July 16, 2024

RE: Proposed 40B – Upton Apartments – 47 Main Street, Upton, MA
Applicant's Response to Memorandum from Daniel Hill, Esq., dated July 5, 2024

Figure 1 — Plan Sheet C-4.0

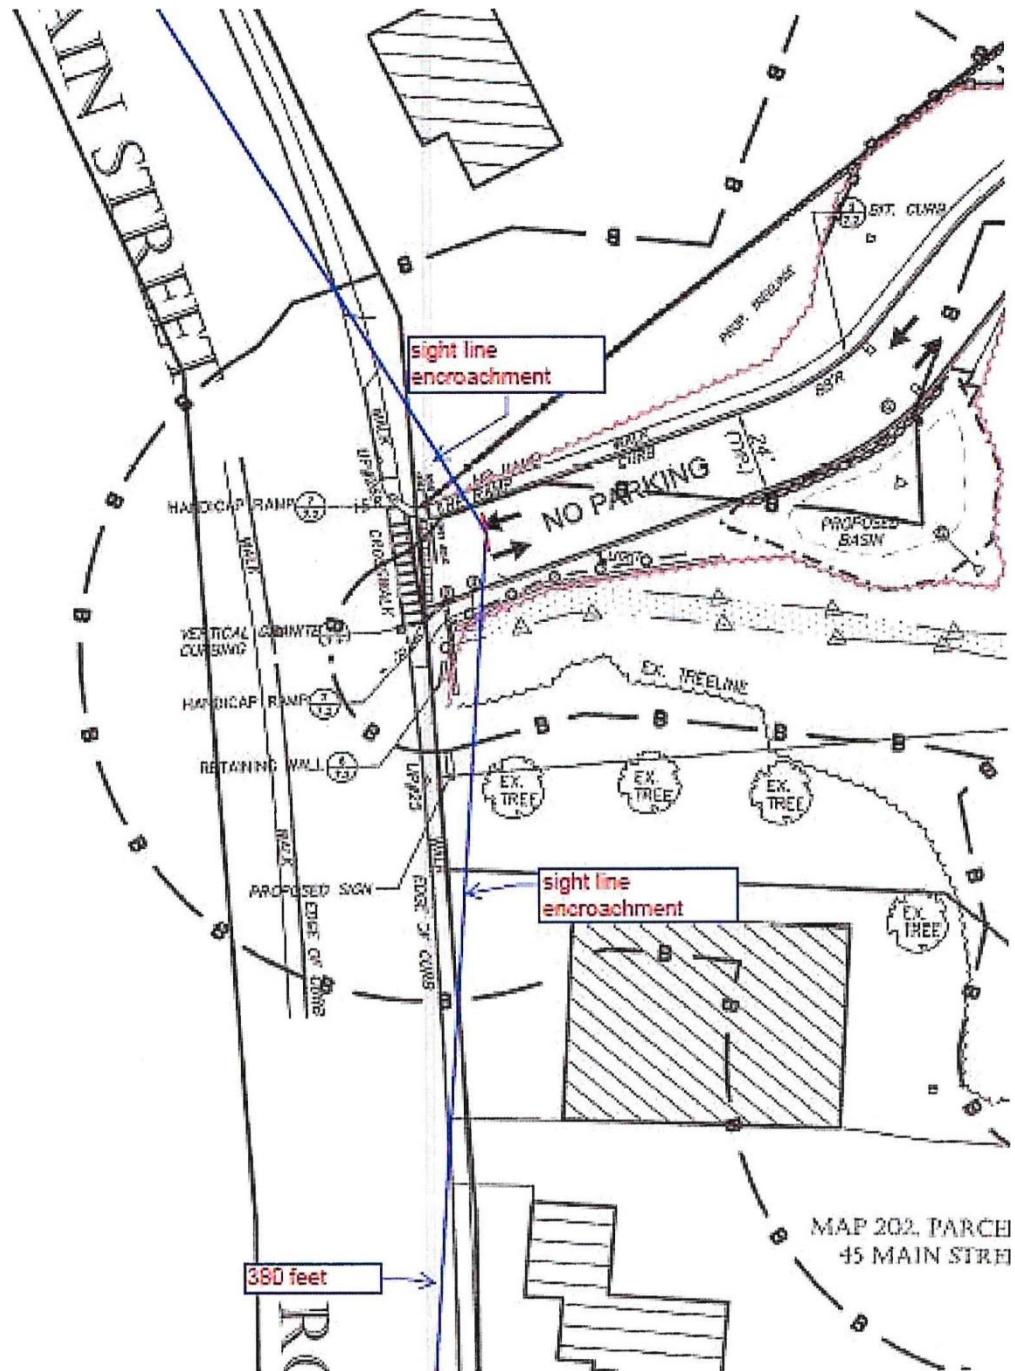
- d. I did not see a roadway profile plan for Project driveway, which is a typical component of a plan set. The grade (slope) of the sidewalk running along the driveway appears to be exceed 6% in some locations (i.e., 338' to 344'), which exceeds the state Architectural Access Board standard of 5%. Accessible routes that exceed 5% are considered "ramps," and appropriate accommodations must be made. I did not see any details of this sidewalk or ramps in the plan set.

Applicant's Response: The site plans have been reviewed by the ZBA, the Upton DPW and the ZBA's peer review engineering professionals. No issues of concern were raised. A roadway profile plan was not required to be submitted. The Applicant will conform to

any Fire Department and DPW requirements as the Project plans are advanced to construction level for purposes of obtaining a building permit. The standard Mr. Hill is referring to is a 5% slope from the handicap parking spaces and the building. This standard would not be used for a sidewalk along a driveway. However, we always strive to have the most safe site possible and we will add notes to the grading plan to ensure the sidewalk is constructed at no greater than a 5% slope. The Project shall also conform to all applicable state Architectural Access Board and federal ADA requirements.

Figure 2 - Architectural Plan 9/7 /23

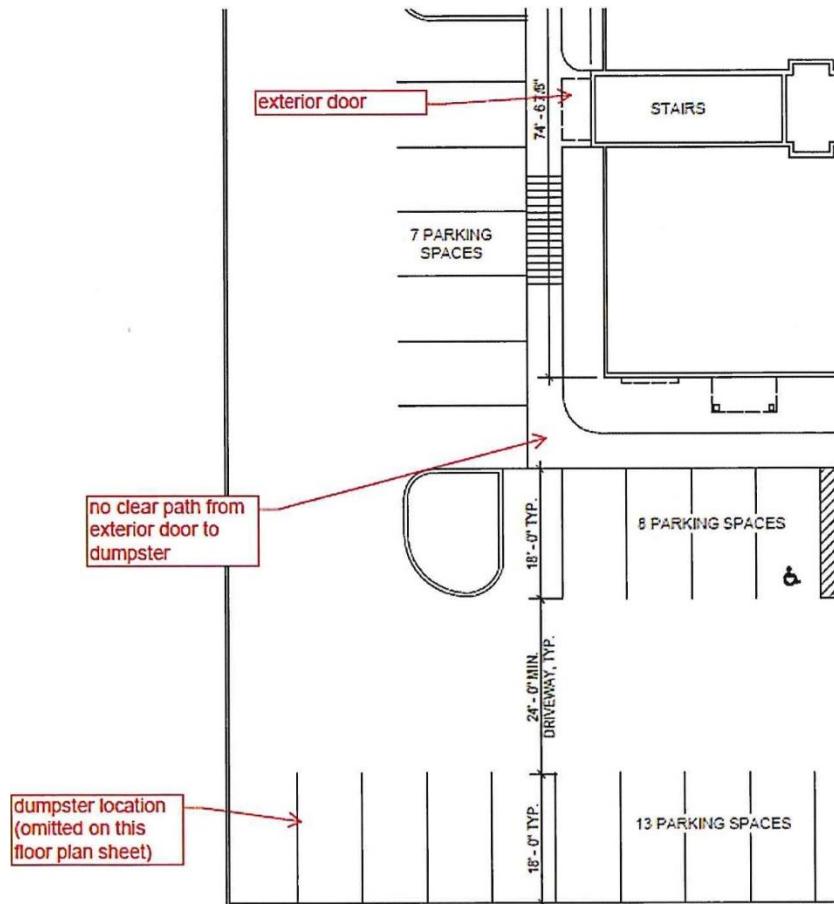
- d. There is no walking path from the side exterior door on the ground level to the rear dumpster - if there parking lot is full of cars, you would have to walk with your trash bags between parked cars. See Figure 2 below.

Applicant's Response: The seven spaces located on the side of the building were removed. This plan reviewed by Mr. Hill is outdated and has been superseded. However, even though it is not required, the Applicant has added a walking path.

Figure 3 — Architectural Plan 9/7/23

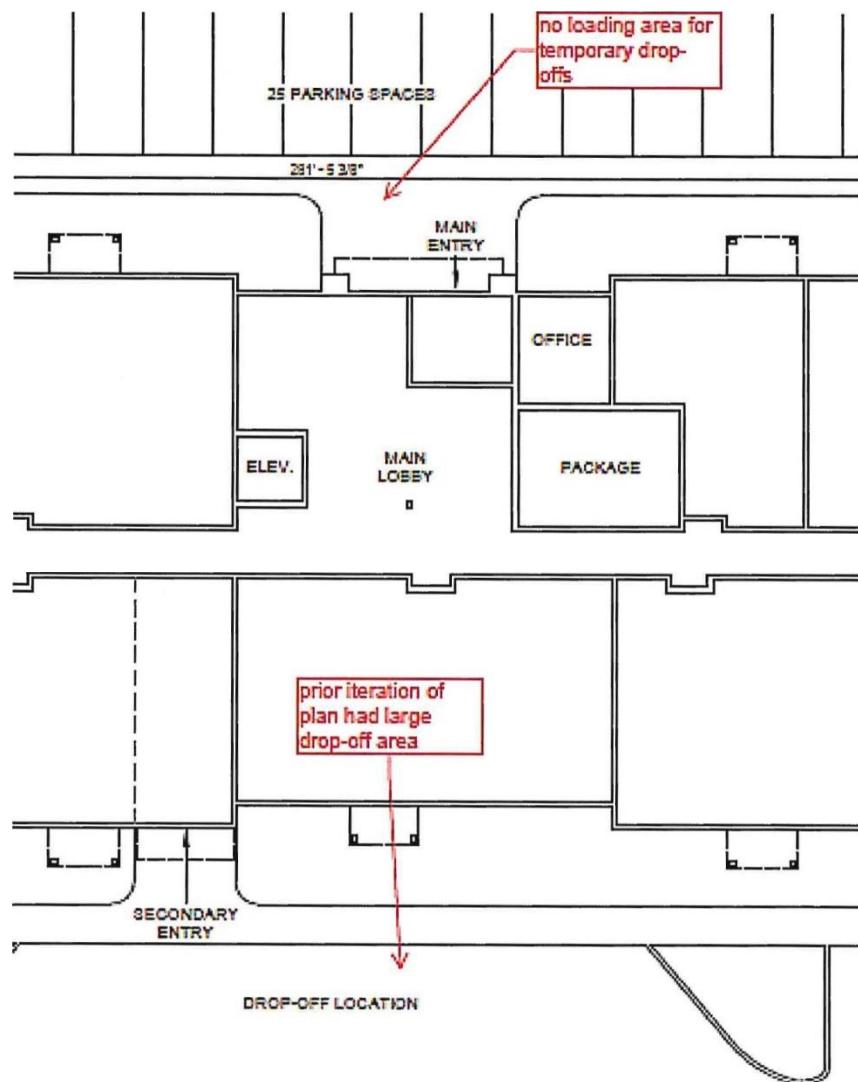
- b. There is no dedicated loading area for temporary vehicle trips, such as drop-offs (e.g., Uber), delivery vehicles, moving trucks, etc. These types of temporary or transient trips are more common in this type of residential setting. Moving trucks will be a regular occurrence because this is a rental property. There does not appear to be any thought or planning into moving day logistics. A moving truck would necessarily block a driveway while loading/unloading. See Figure 3 below.

Applicant's Response: Once again, Mr. Hill uses an outdated plan set. A temporary vehicle area was added in later site plans. Vanasse and the ZBA's Traffic Peer Reviewer agree that the number of parking spaces provided is adequate. Move-ins will be coordinated by property management—spaces will be reserved for moving vans. This is how it works at all multifamily properties. As to EV Charging Stations, locations will be finalized based upon latest technology at time of installation. A temporary vehicle area was added in later plan revisions.

Figure 4 - Plan Sheet C-4.0

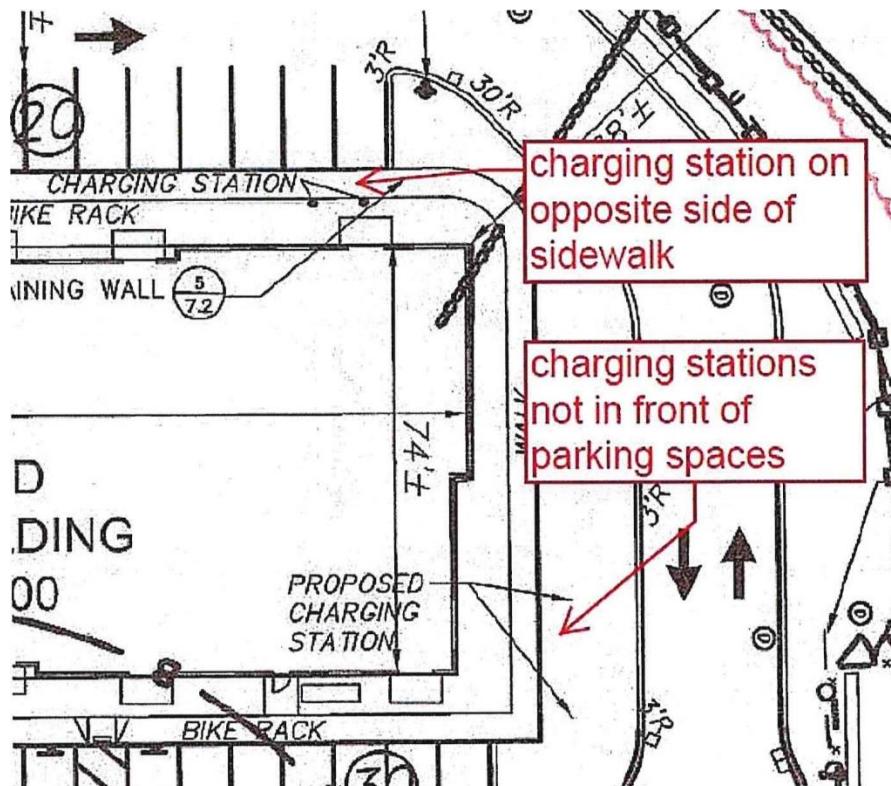
d. Two EV charging stations are apparently proposed on the northerly side of the building. This is not practical, as there is no parking spaces on that side of the building. A charging station needs to be located in front of a parking space. Two charging stations are proposed near parking spaces on the west side of the building, but they are shown on the far side of the sidewalk opposite the parking spaces, which is also not practical. A charging station has a cord to connect to the car, and this cord would block the sidewalk, even if it were long enough. Suggest that the Applicant visit a parking lot with charging stations to better understand how these work. See Figure 4 below.

Applicant's Response: The Applicant has proposed 6 charging stations. The Applicant has installed electric charging stations before and has them at other projects which are either owned or managed by the Applicant, so the Applicant knows how they work. The old label is from a previous, outdated plan.
